HORWICH HEALTHCARE HUB

DETAILED DESIGN REPORT

REPORT REFERENCE NO. J004610/7405/02

December 2023

Drawing 1. Proposed Floor Construction

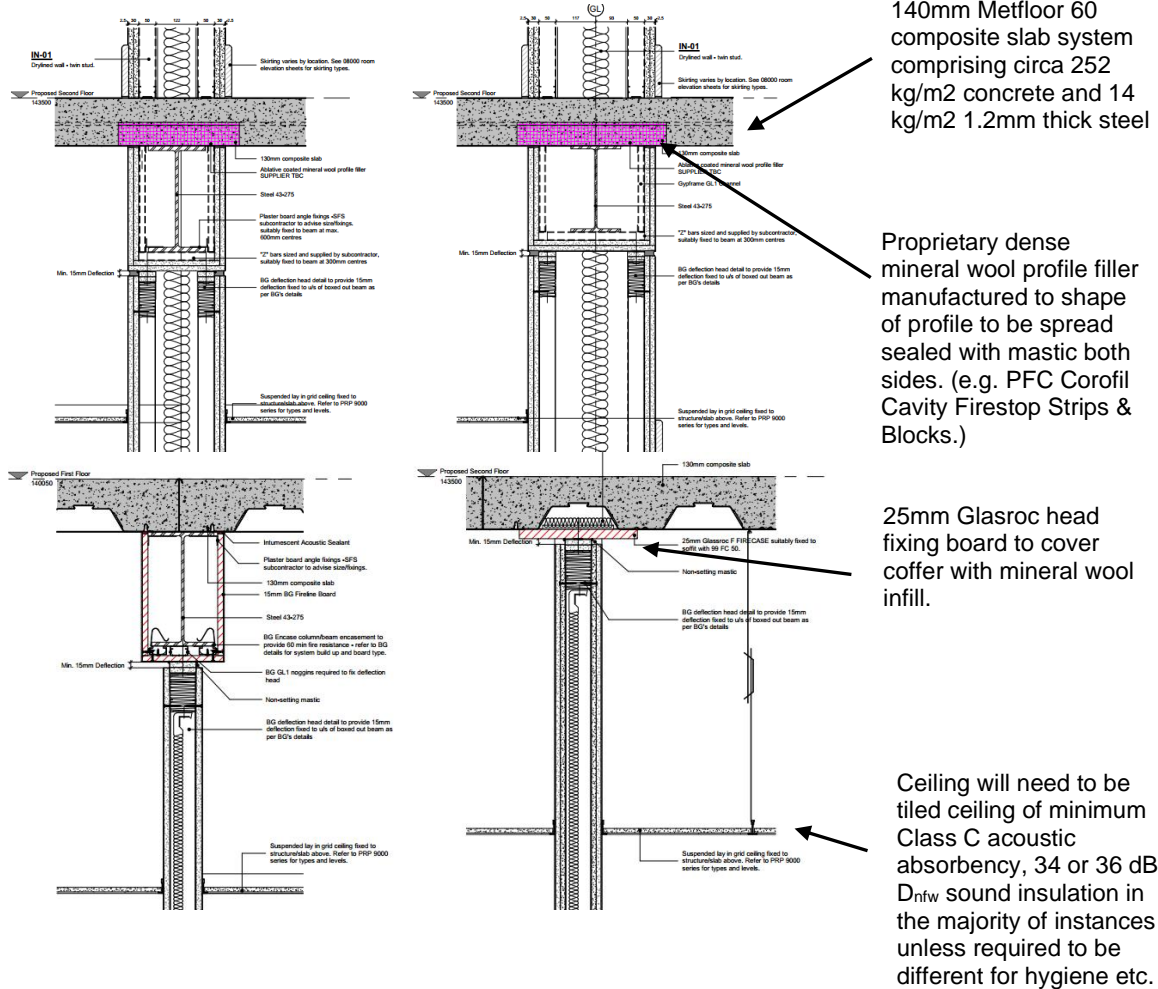
The following construction will be required to have an absorbent ceiling of minimum Class C absorption and 34 (Noise sensitive non-clinical areas) and 36 dB D_{nfw} (Noise sensitive clinical areas) ceiling sound attenuation except as required for hygiene etc. and this is shown in the drawings. In addition the floor will need to be finished in carpet or vinyl with minimum impact sound insulation of 10dB ΔL_w . As such the revised floor/ceiling build up would be:

- Where rooms overly noise sensitive rooms a carpet or vinyl surface finish minimum impact insulation 10 dB ΔL_w will be required. I note that the current drawings correctly reflect this on the upper floors with the 17dB ΔL_w Forbo Surestep Decibel Slip Resistant Safety Vinyl specified apart from as follows:
 - **First Floor F.16 Reception currently shows standard vinyl but will need to be upgraded to the Forbo Surestep Decibel Slip Resistant Safety Vinyl as there is a clinical area below.**

- **I note that the Internal Detail Sections Sheets 1 to 6 show 130mm thick concrete composite slab but it is understood that this should actually be 140mm thick.**

- 140mm Metfloor 60 (or equivalent) re-entrant profile Composite Deck (or equivalent mass deck with trapezoidal profiles).
- Minimum 500mm void.
- 34 dB D_{nfw} (Noise sensitive non-clinical areas) or 36 dB D_{nfw} (Noise sensitive clinical areas) Class C acoustic ceiling e.g Zentia Bioguard Acoustic.

Calculations indicate that the airborne acoustic performance of this system would be in excess of the site requirement of 47 dB $D_{nT,w}$, this being the minimum performance requirement. The above is as shown in the detailed drawings.

Drawing 2: Junction of internal partition with ground floor (acoustic principles only)

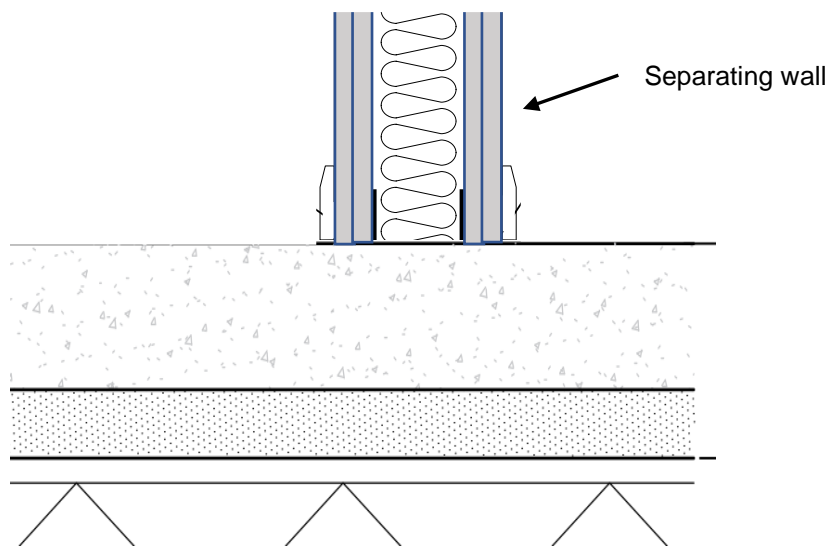
Please refer to Drawing 3 below which provides our recommended detail which appears to be correctly shown in the GA section drawings.

It is noted that if any floating floors are proposed then these should be broken either side of the partition base.

Junctions of the base of internal partitions with upper floor 140mm thick concrete slabs must also meet the suspended concrete base slab in a similar way to the ground floor slab junction shown in Drawing 2 above.

Drawing 3. Partition head to Steel Beam - vertical section (acoustic principles only)

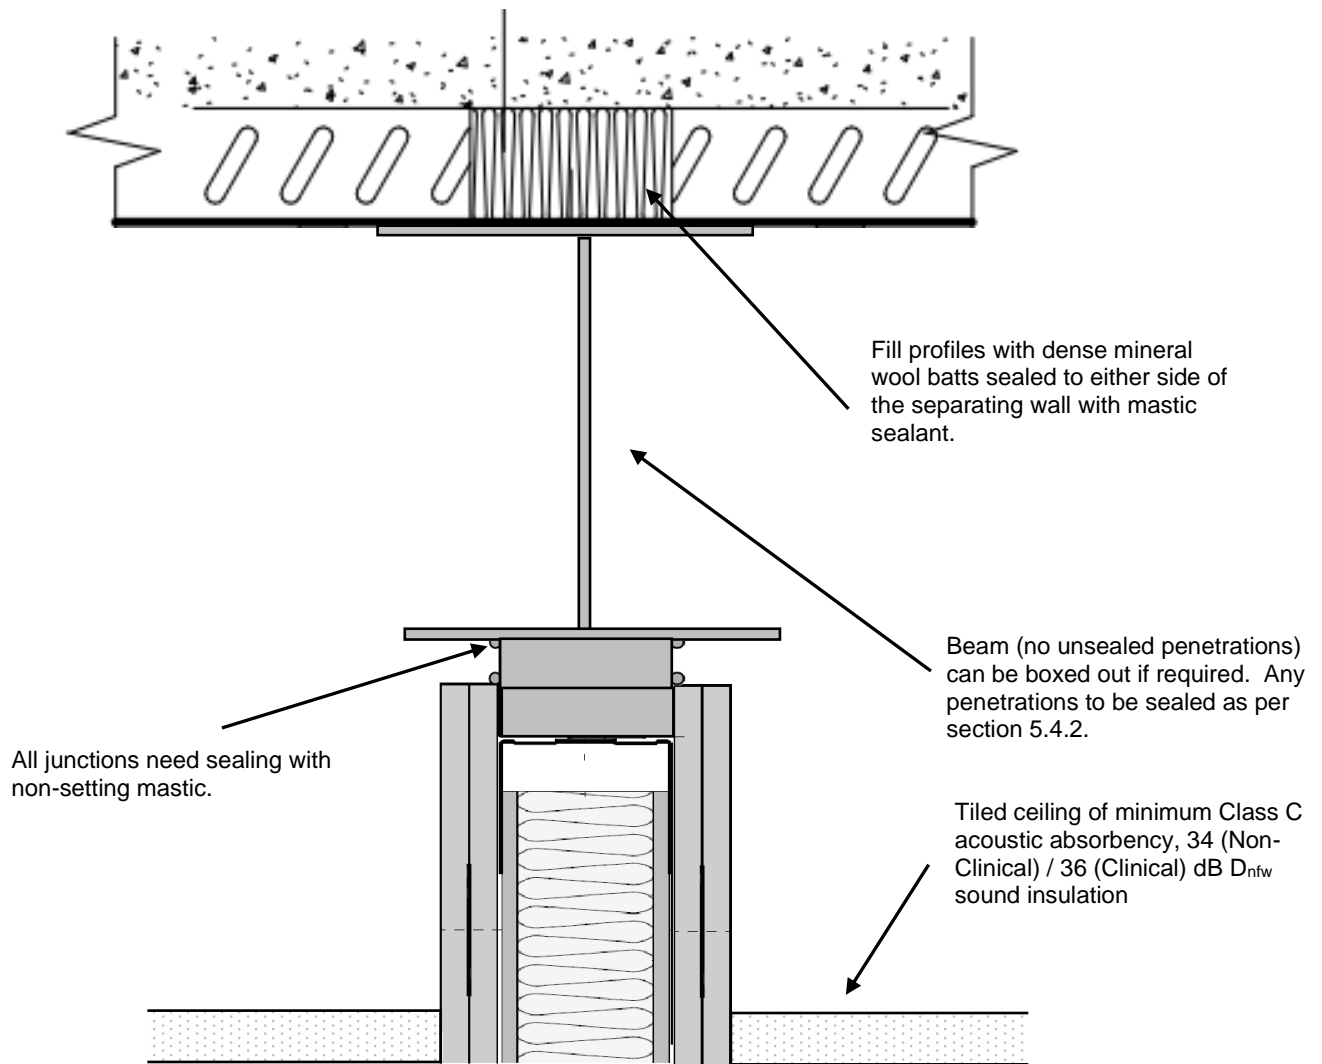
Drawing 3 below shows typical requirement where a partition meets the underside of a steel beam:

It is of course acceptable to box out the beams if required for fire etc., and the current drawings are acceptable in that respect.

Drawing 4. Potential Beam offset to Wall Details (acoustic principles only)

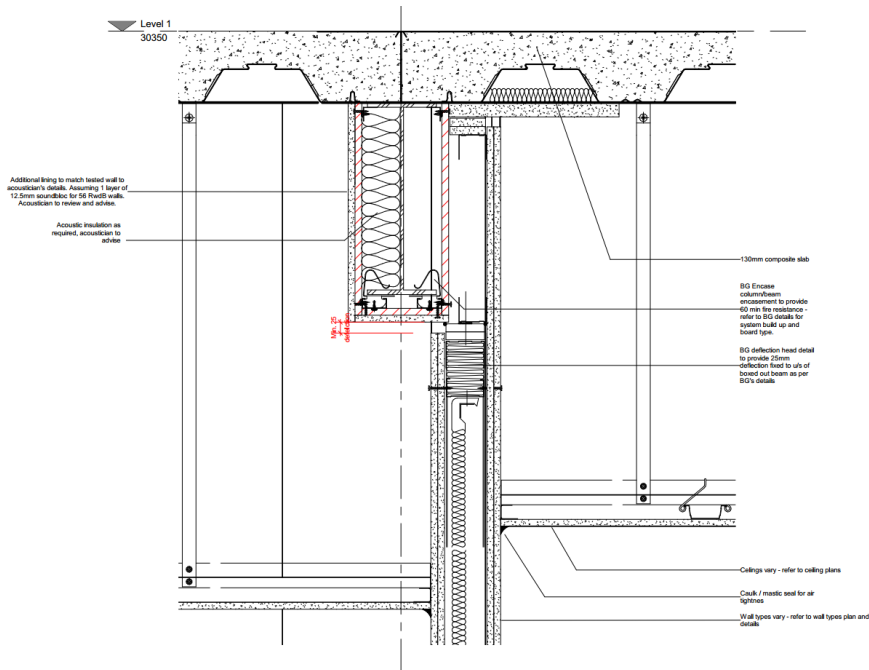
I note that where partitions are offset from beams but still within the footprint of the beam then it makes sense to box out the beam as per previous projects as shown in Drawing 4 below:

Drawing 5. Roof Junction Details (acoustic principles only)

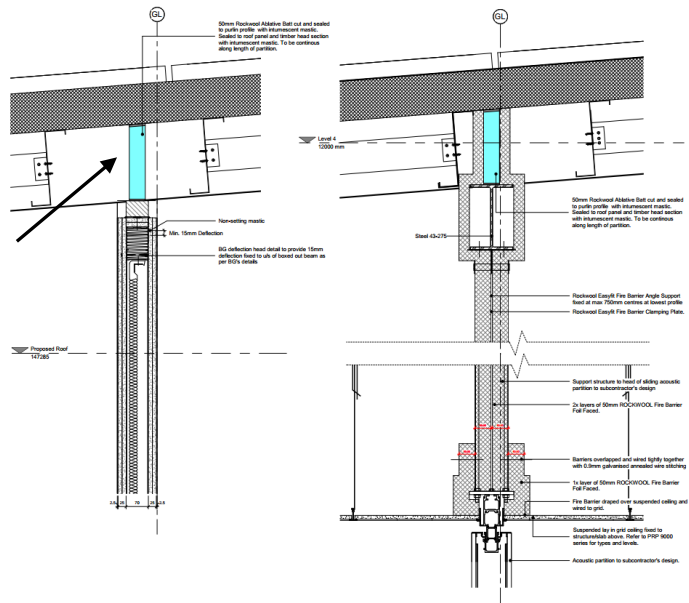
Acceptable roof head details as detailed below are shown in the current PRP drawings:

Mastic sealed ablative board head seal.

Moveable wall head detail (Brew to Staff Room)

- Example suppliers we have worked with before are Accordial, Huffcor and Style amongst others.
 - For the movable wall shown between Brew Space and Staff Room then the current details above wall head with two layers of foil faced mineral wool sealed at all perimeter, joins and penetrations with non-setting mastic would be acceptable (see drawing 5 above).

Drawing 6. T-junction plan details (acoustic principles only – adapt as necessary for single board partitions)

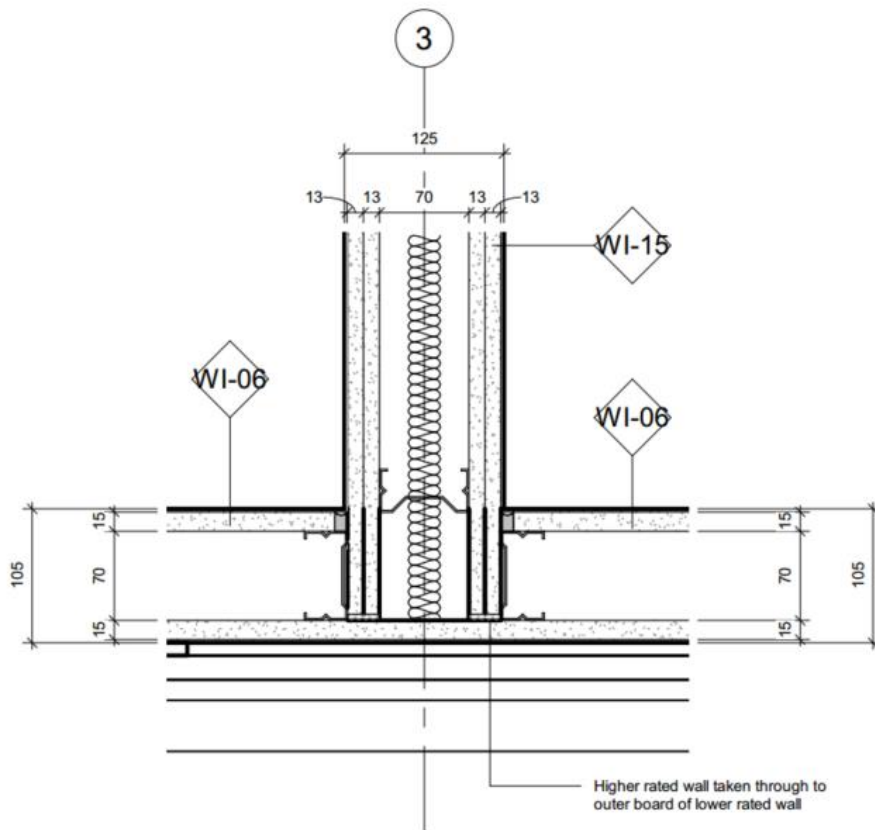
Due to the use of single layers of plasterboard on corridor walls then where a separating partition meets a corridor wall, the separating partition should dominate the junction. The inner leaf of the corridor wall should be discontinuous across the separating partition and break the cavity of the corridor wall, as shown below:

Similar details as set out in the PRP drawings are acceptable.

Drawing 7. T-junction plan details (acoustic principles only– insulation omitted for clarity)

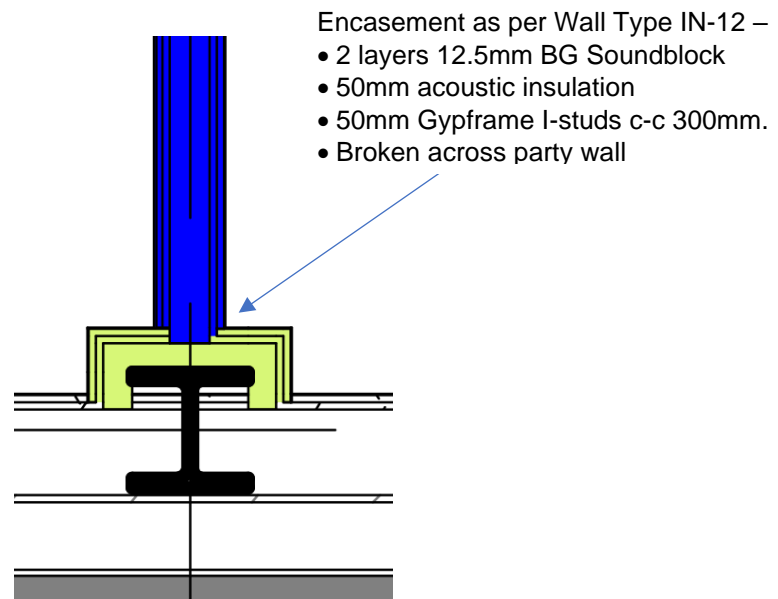
Where partition walls meet a column then the wall system must effectively encase the column in equivalent plasterboard linings to the wall system.

The above detail is correctly shown in the wall type drawings.

Drawing 8. Junction of partition with external wall - plan

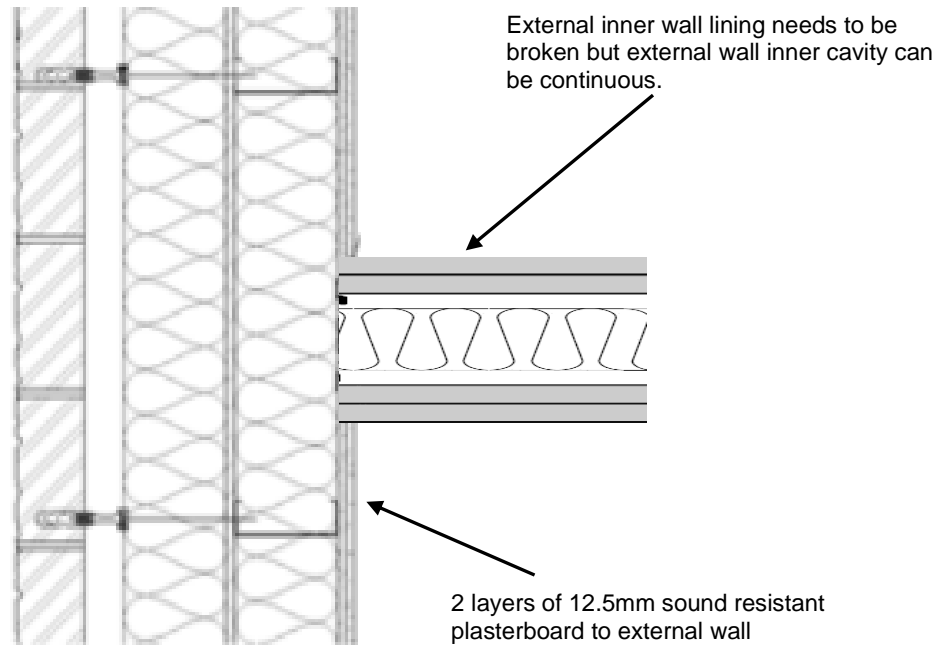
Due to the use of double layers of plasterboard on inner linings of external walls then where a separating partition meets a corridor wall, the separating partition should dominate the junction but does not need to fully close the junction. The inner leaf of the corridor wall should be discontinuous across the separating partition and break the cavity of the corridor wall, as shown below:

Please note that walls of less than 45 dB R_w can but against the external wall lining without breaking it.

The above is correctly shown in PRP Architects drawings.

Drawing 9. External wall and separating floor junction detail – vertical section (acoustic principles only)

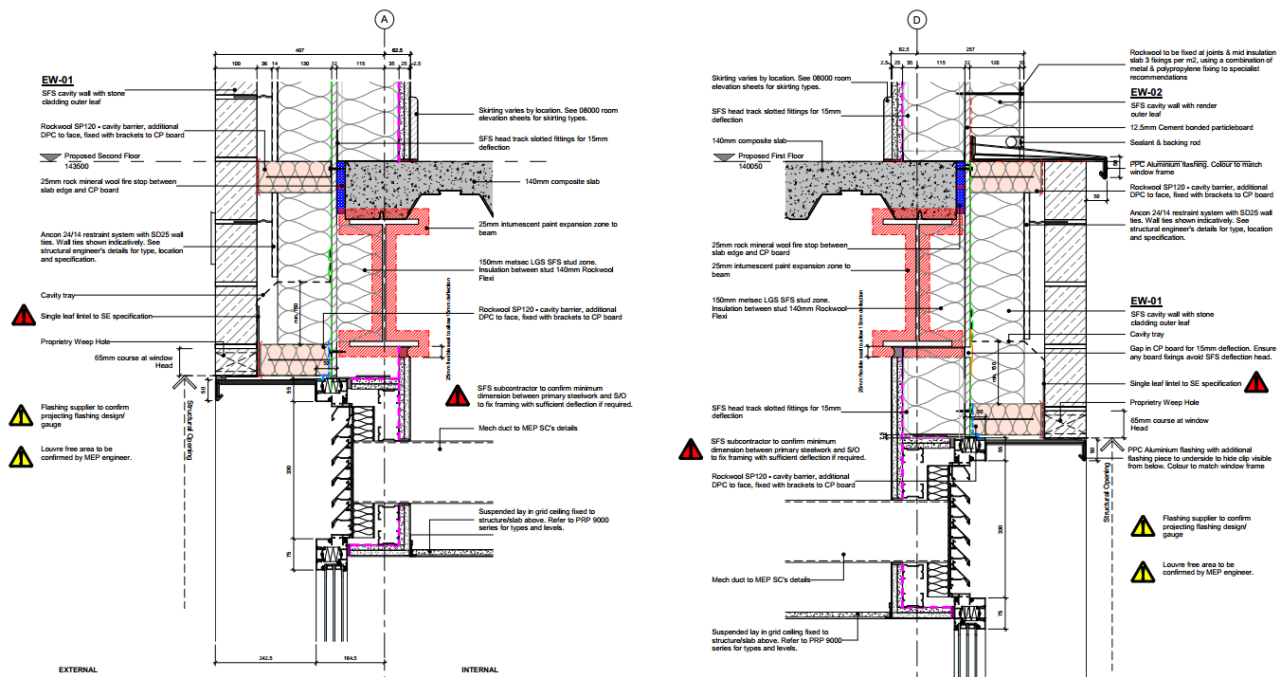
The structural floor slab should be built into the inner leaf of the external wall to ensure no continuous inner leaf between floor levels. A cavity stop should be used to fill the cavity in external walls along the line of the separating floor where appropriate.

It is noted that in the second drawing there is a louvre backed with an insulated (PIR) metal sandwich panel. It is understood that this instance would only occur above ceiling height and below window sill height in noise sensitive rooms and is therefore acceptable due to the attenuation of the ceiling.
